**IOWA DEPARTMENT OF TRANSPORTATION**

**TO OFFICE:** District 4  
**ATTENTION:** Wes Mayberry  
**FROM:** Alfred Benesch & Company  
**OFFICE:** Design  
**SUBJECT:** Field Exam (D-2)

**DATE:** March 16, 2018  
**REF.:** Pottawattamie County  
IMX-029-4(112)72--02-78  
BRFIMX-029-4(113)72--14-78  
PIN: 16-78-029-070

A field exam was held on Thursday, February 1, 2018, to review the proposed plan for the bridge replacement at County Road G12 over I-29 in Pottawattamie County.

G12 AND RAMPS  
 DETOUR PAVEMENT

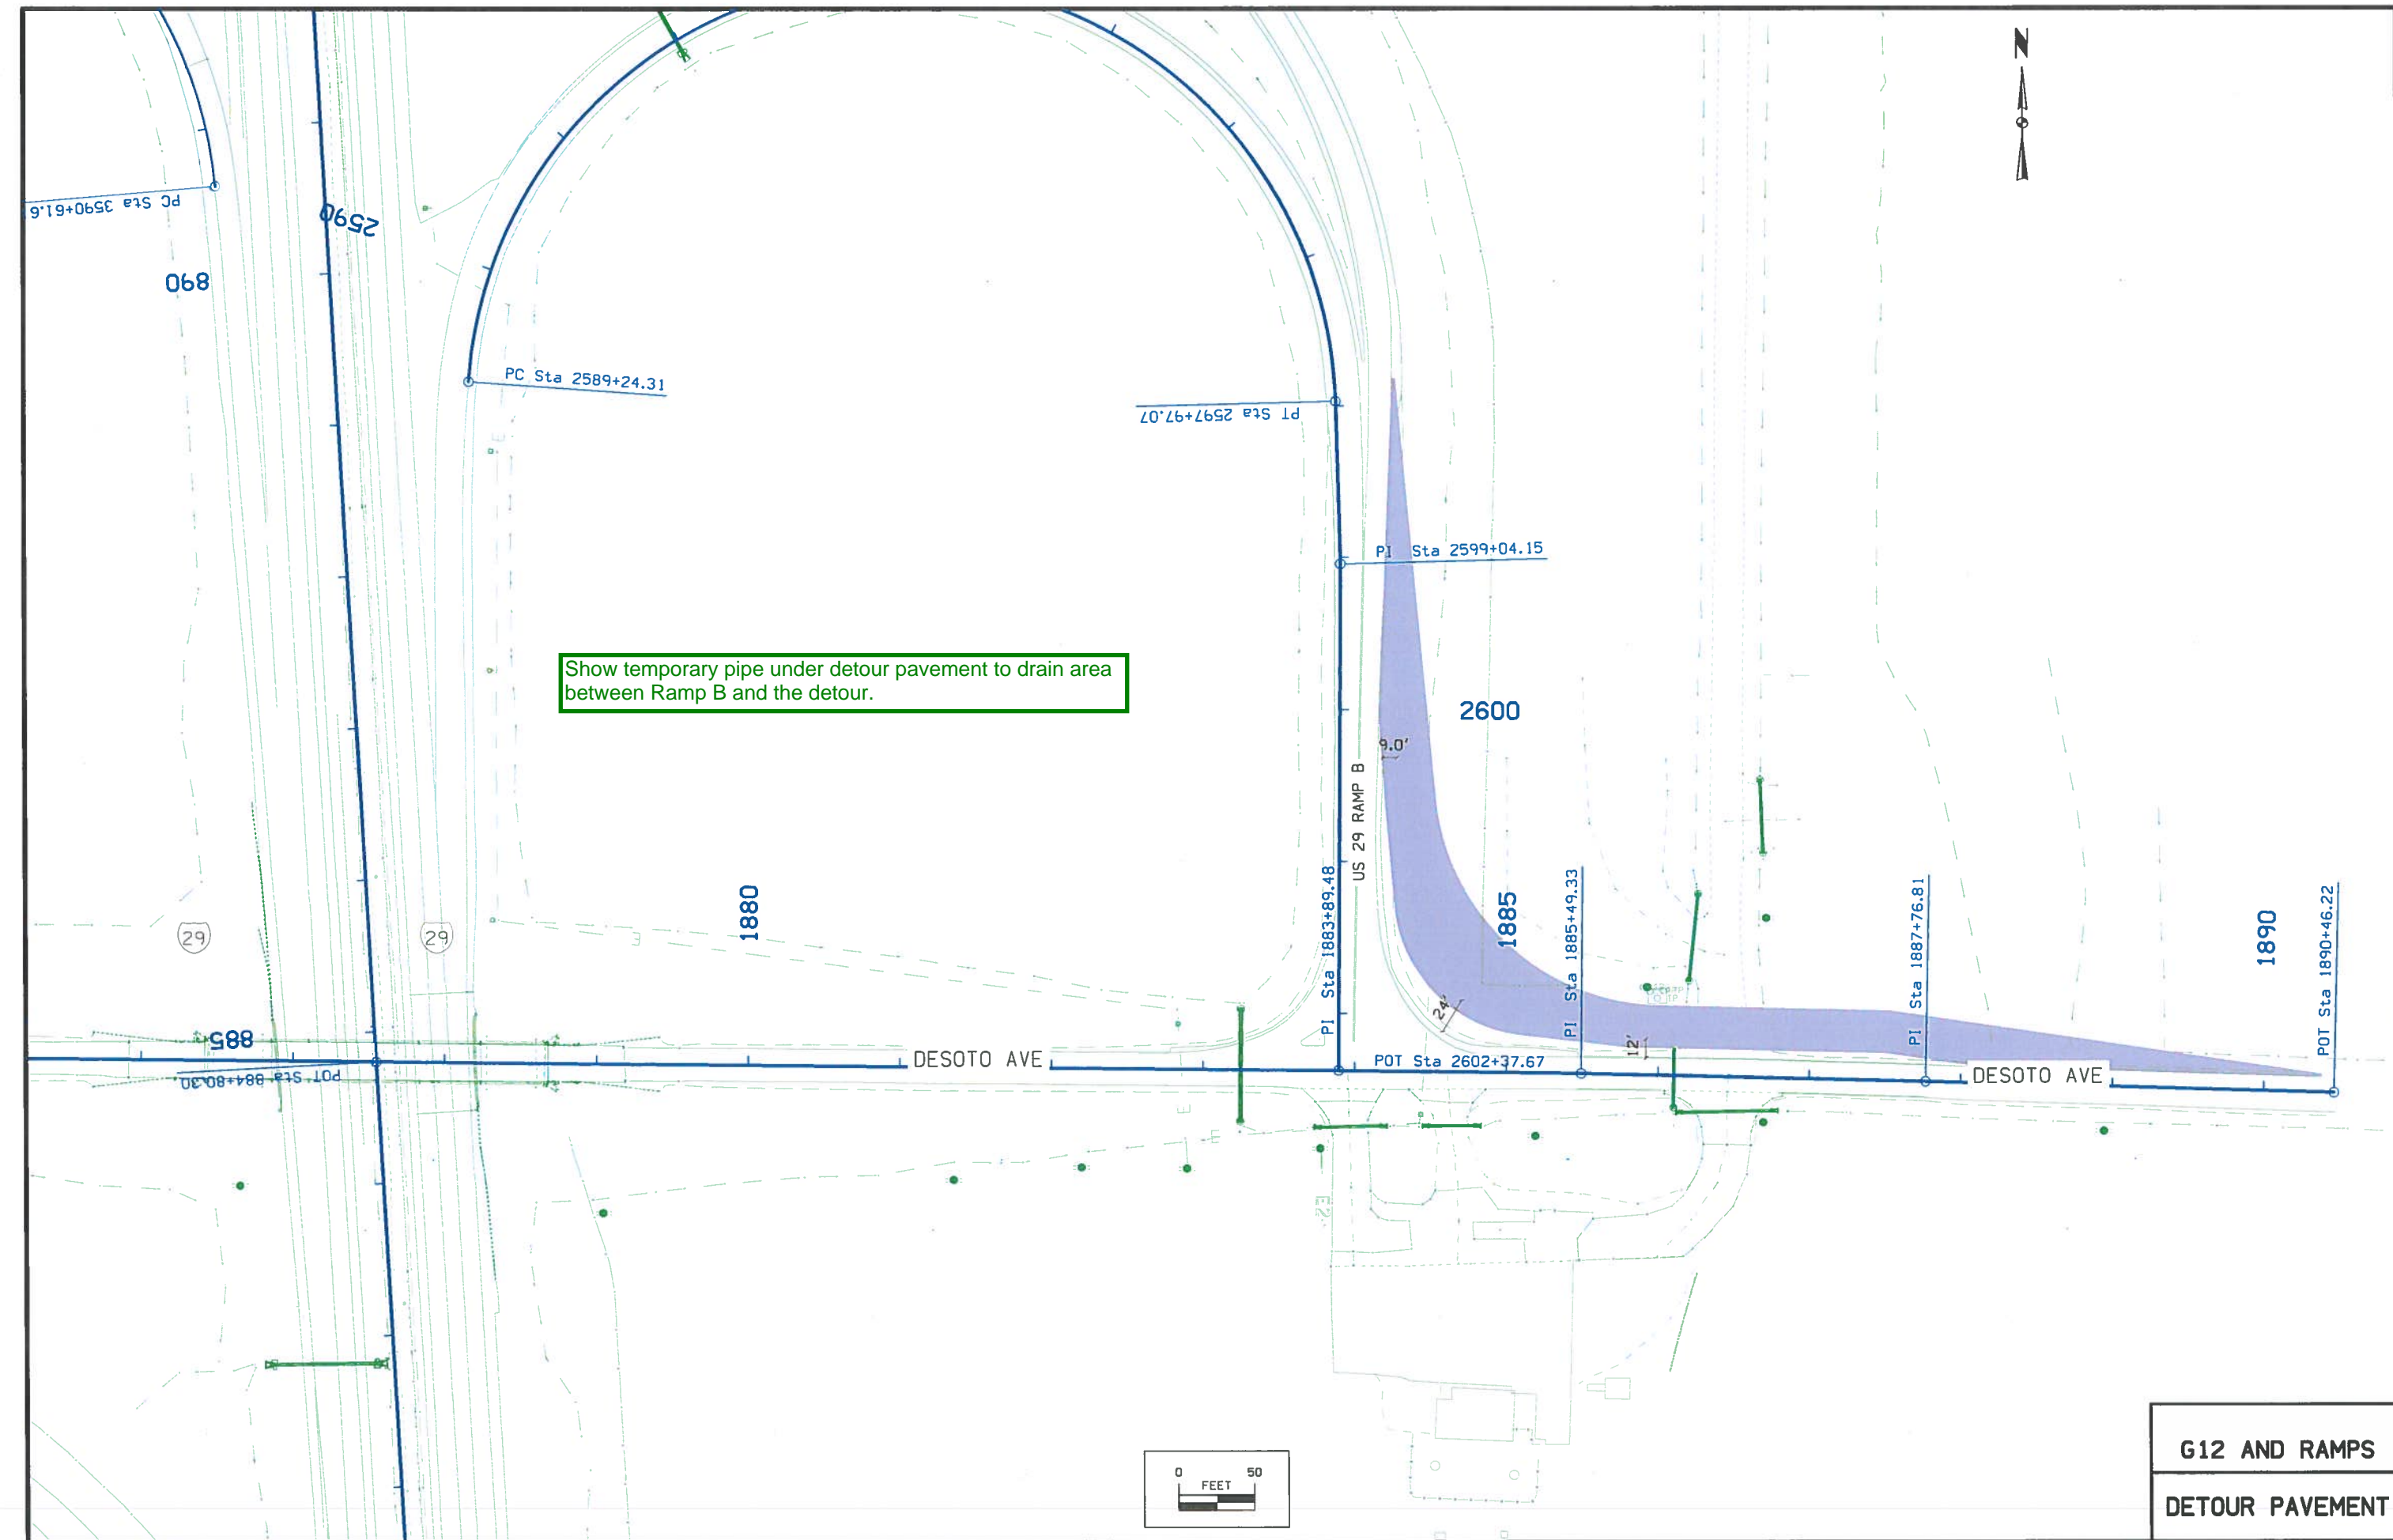
Show temporary pipe under detour pavement to drain area between Ramp B and the detour.

STAGE 1  
DETOUR ROUTE OF  
G12 EASTBOUND

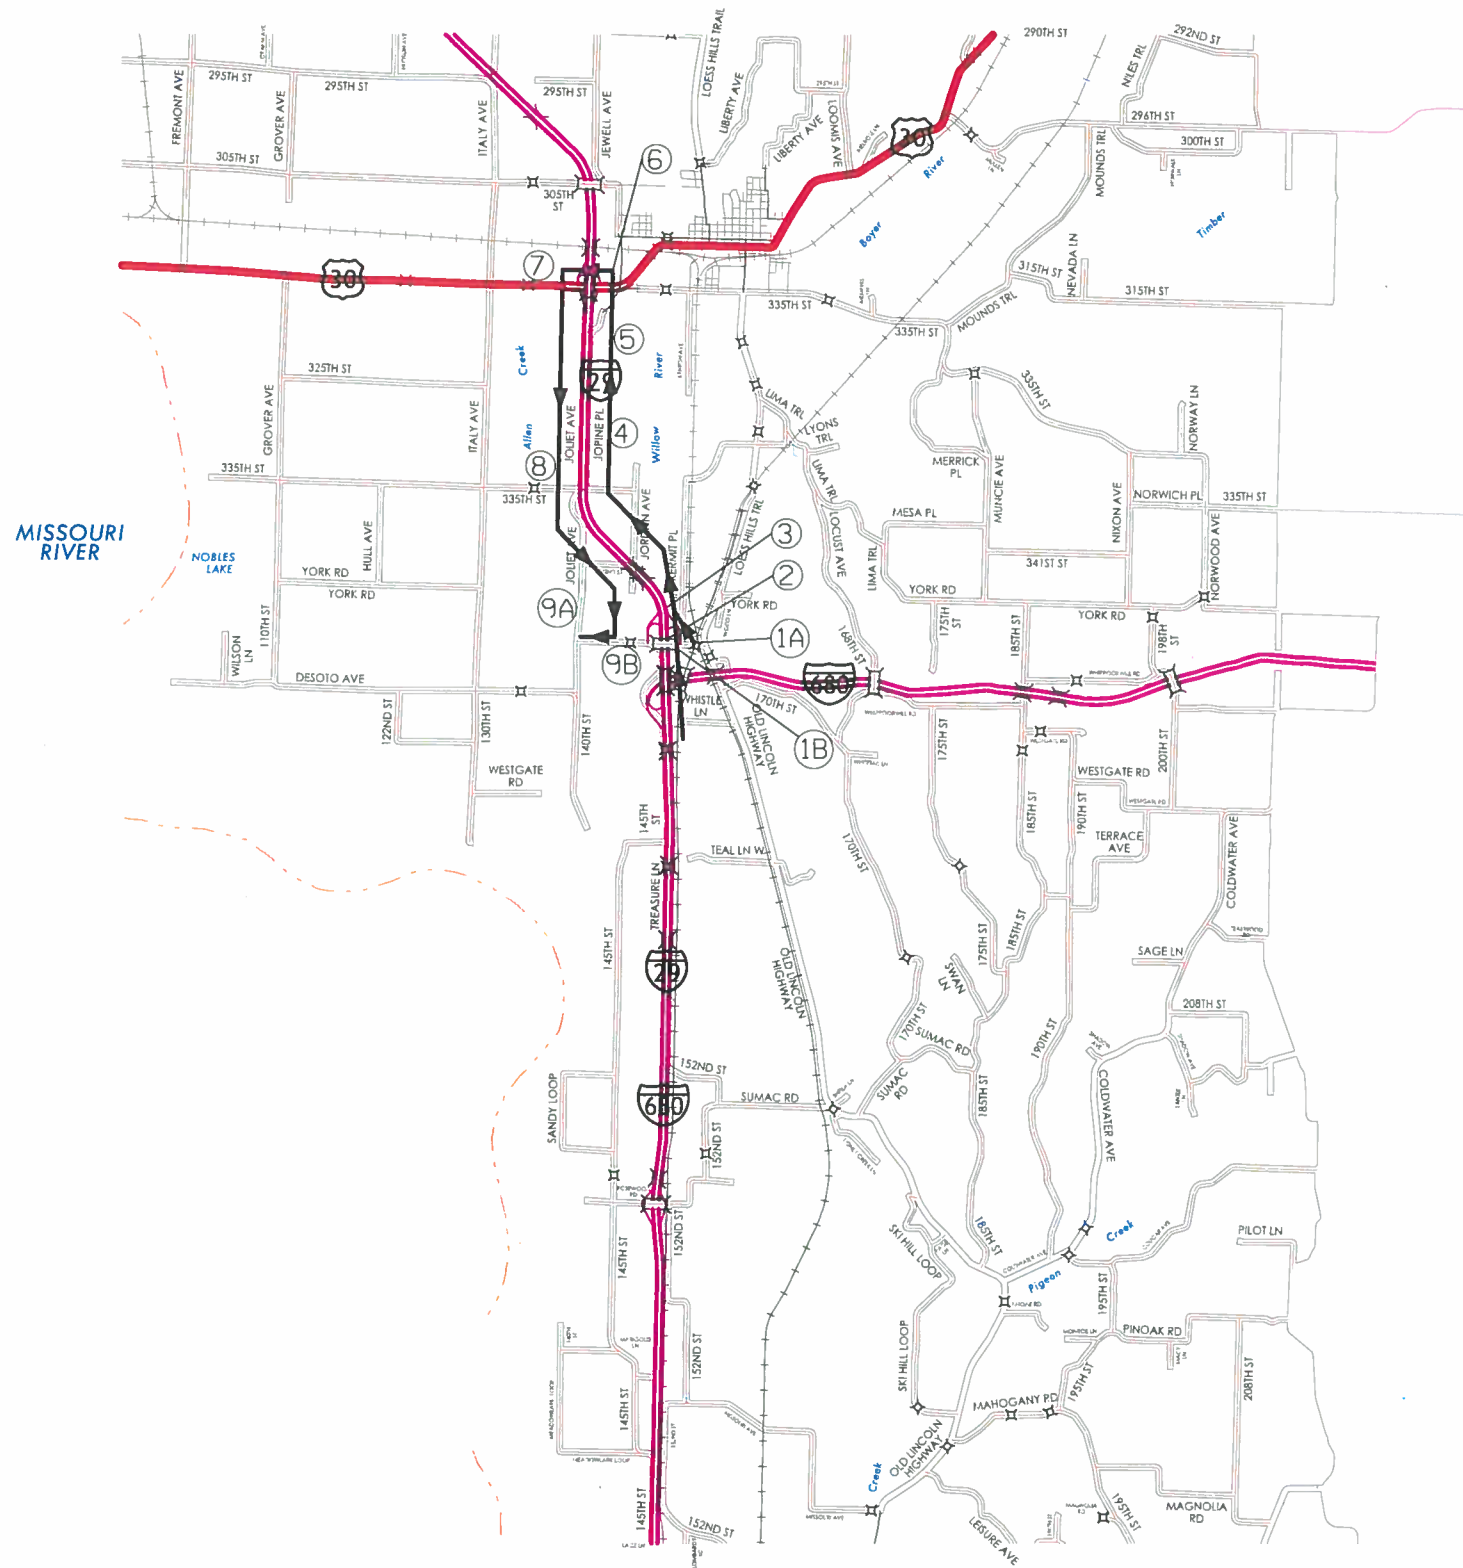
height restrictions  
mean NO TRUCKS on detour

STAGE 1  
STAGING PLAN

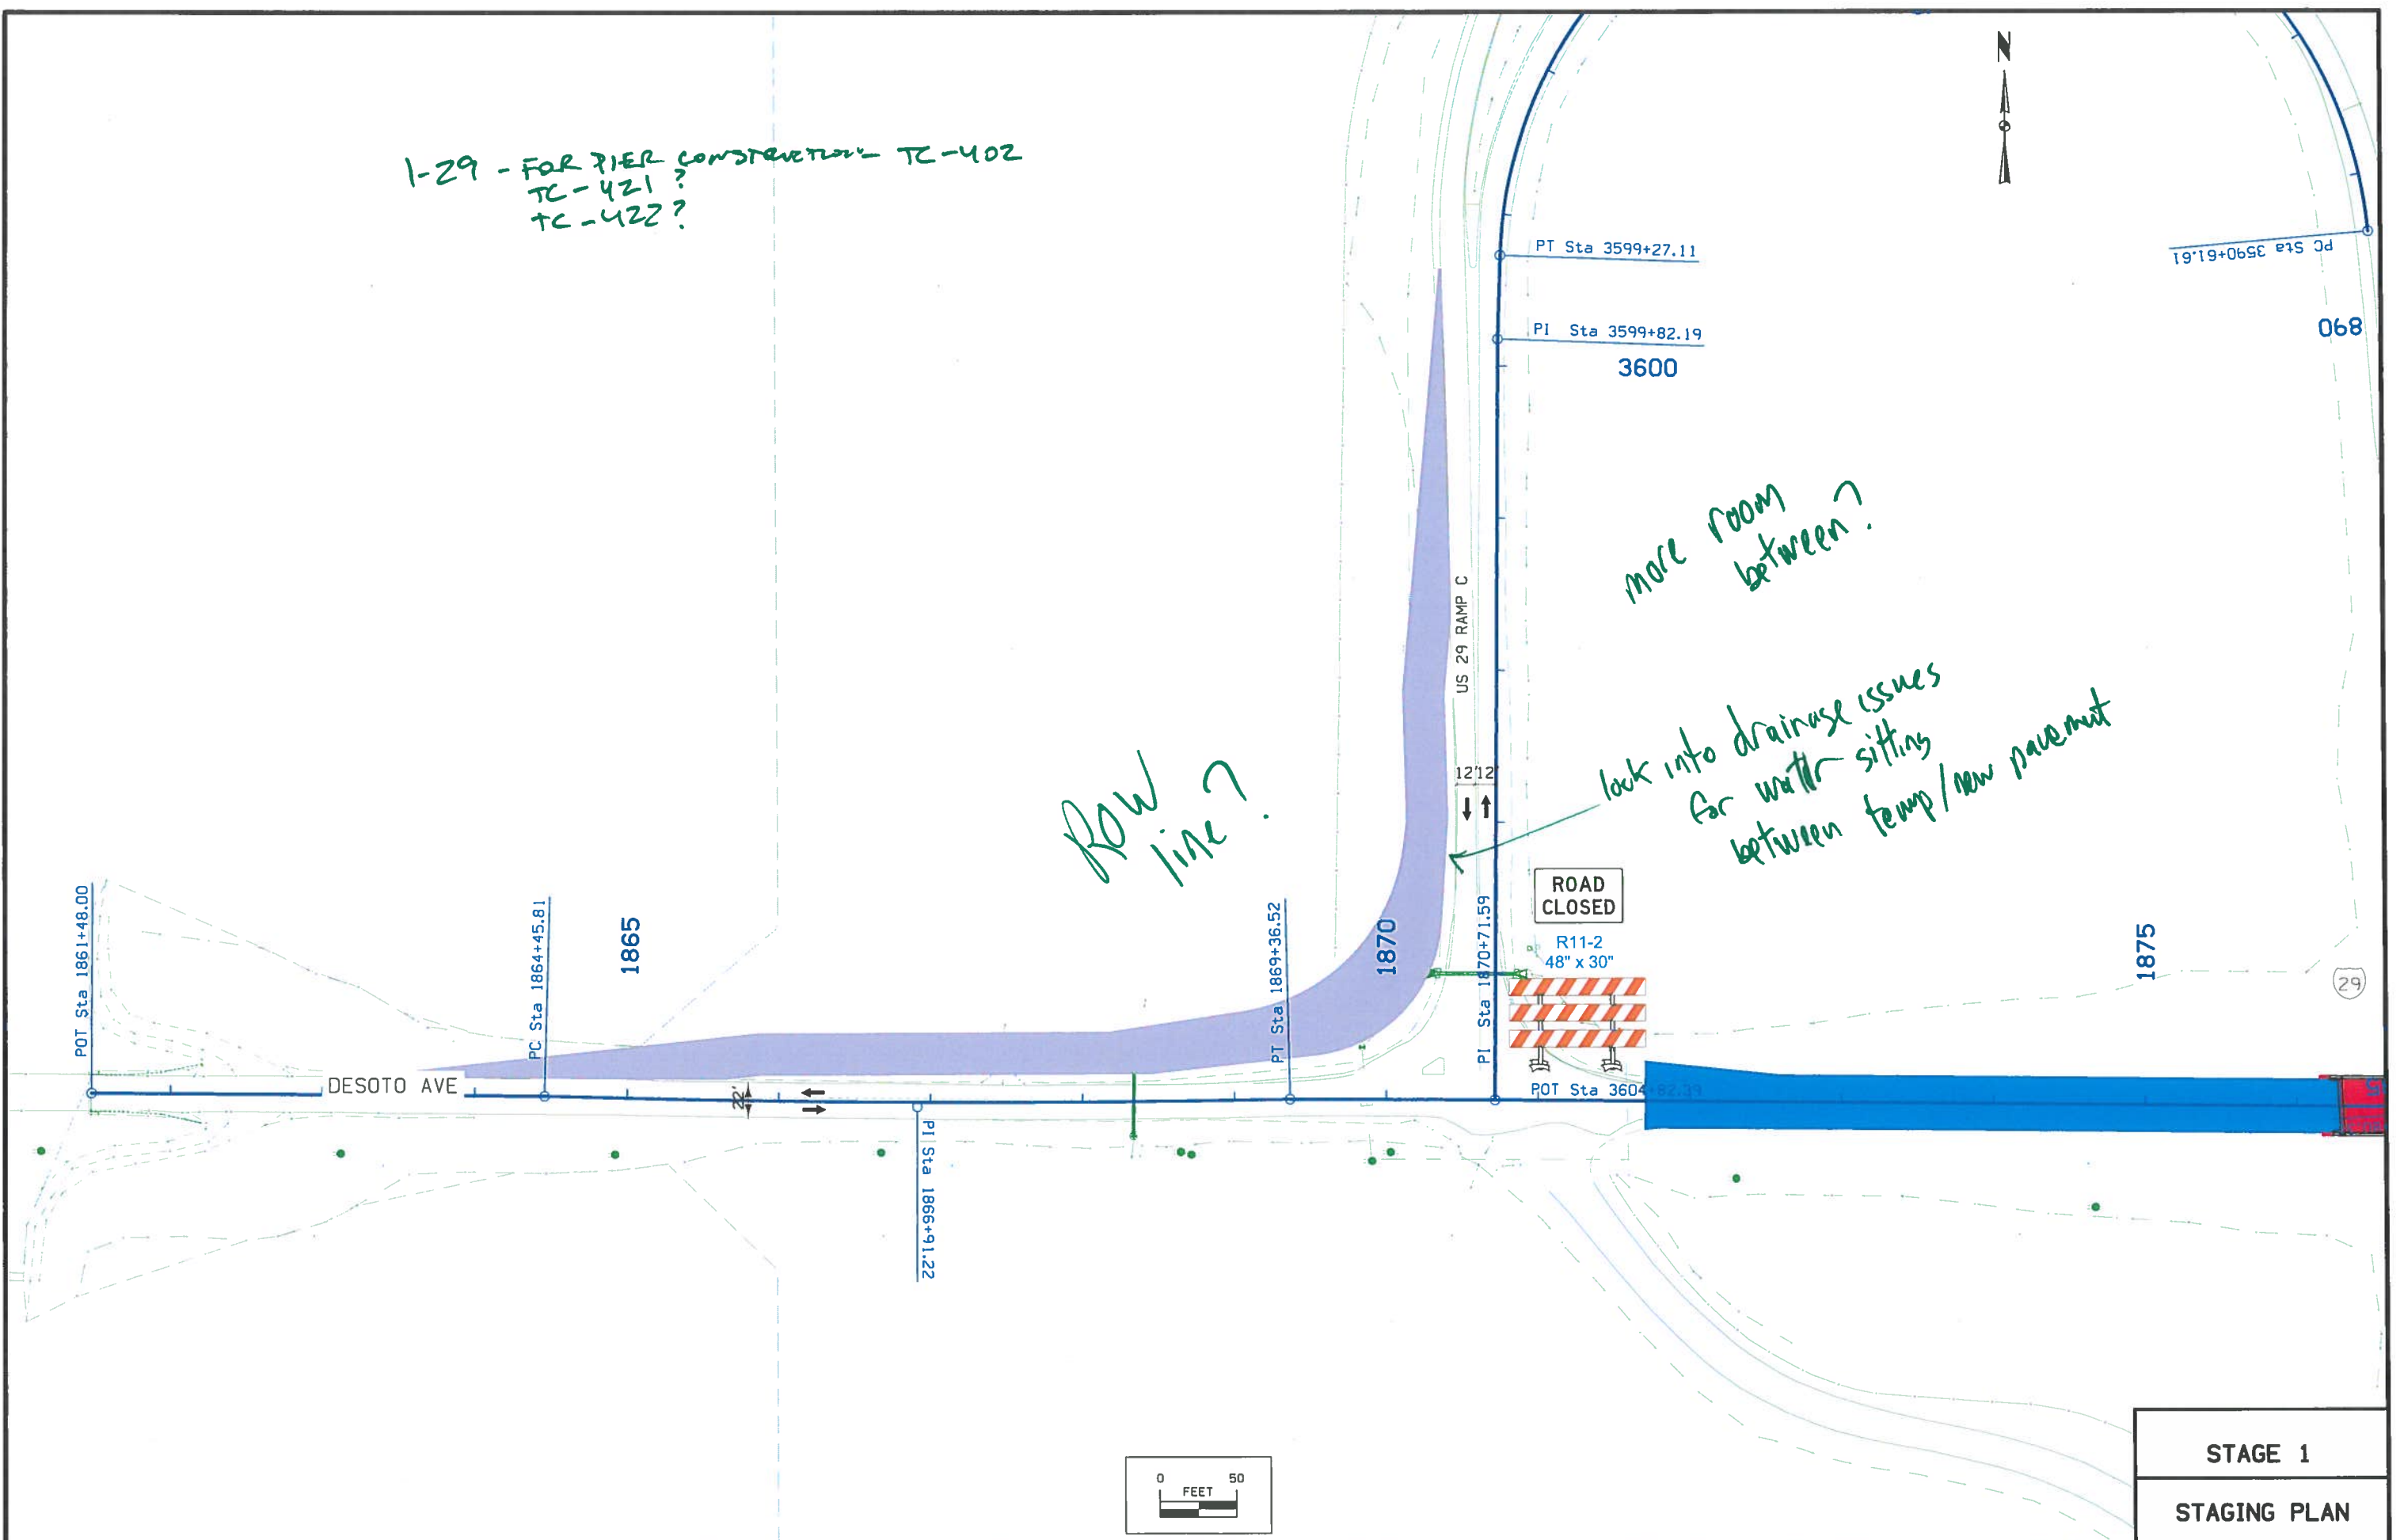
1-29 - FOR PIER CONSTRUCTION - TC-402  
TC-421?  
TC-422?

ROW  
line?

look into drainage issues  
for water sitting  
between temp/new pavement
